MSATS Standing Data Review

CONSULTATION – Second Draft Stage

CONSULTATION PARTICIPANT RESPONSE TEMPLATE

Participant: PLUS ES

Figure 1 Current drafted Shared Isolation fields

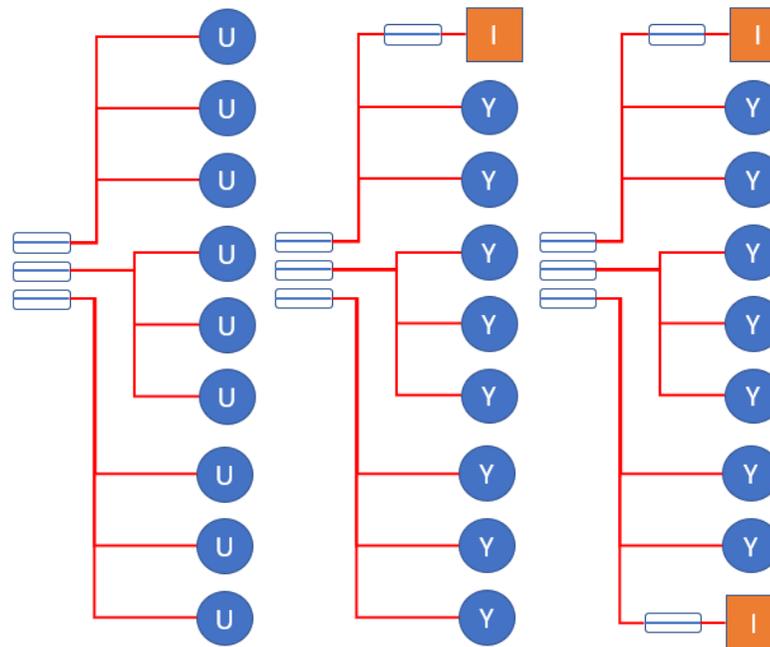
| Heading | Participant Comments |
|--------------------------|---|
| Shared fuse arrangements | <p>PLUS ES supports the changes drafted to meet the requirements of the NER rules recently implemented for shared isolation points.</p> <p>PLUS ES further recommends figure 2 below to be considered as an additional proposal to the current draft. Capturing the additional link between the shared isolation point and the directly impacted meters would drive further efficiencies across Retailers, MCs and DNSPs, such as but not limited to:</p> <ul style="list-style-type: none">• a reduction of costs: avoid unnecessary visits to sites, communications to customers which are not impacted by the planned interruption• streamlined utilisation of resources, better management and compliance to timeframes• better outcome for customers, irrespective if they are the requesting party for the metering installation or just an impacted consumer of the planned interruption. <p>The NER does discuss shared fuse arrangements and figure 2 is a depiction of existing valid shared fuse arrangements.</p> |

Figure 2: Alternative Proposal

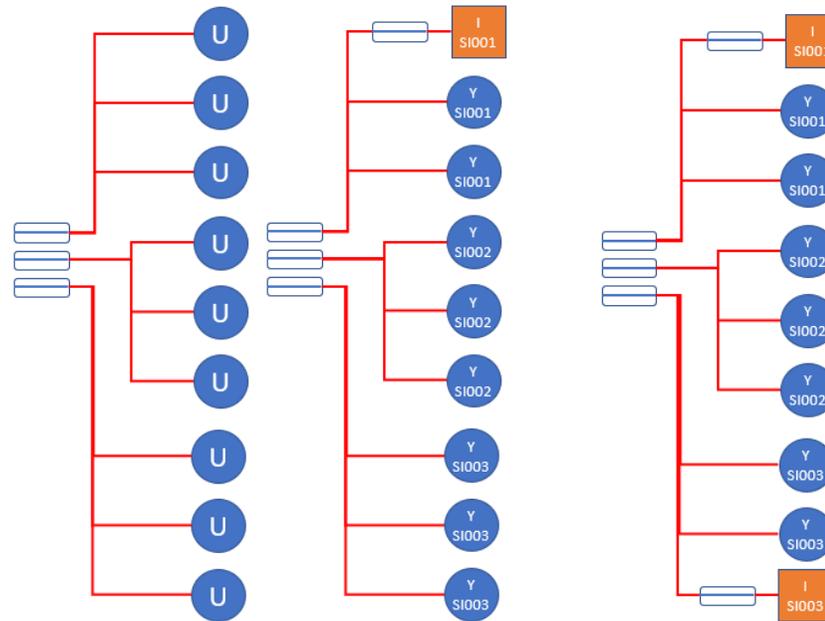
Second and subsequent isolation MP can see from Flag and Index that Network Isolation required Network. **Network does not need to visit site to do reconnaissance, appointment set only for customers connected to SI003 Shared Isolation**
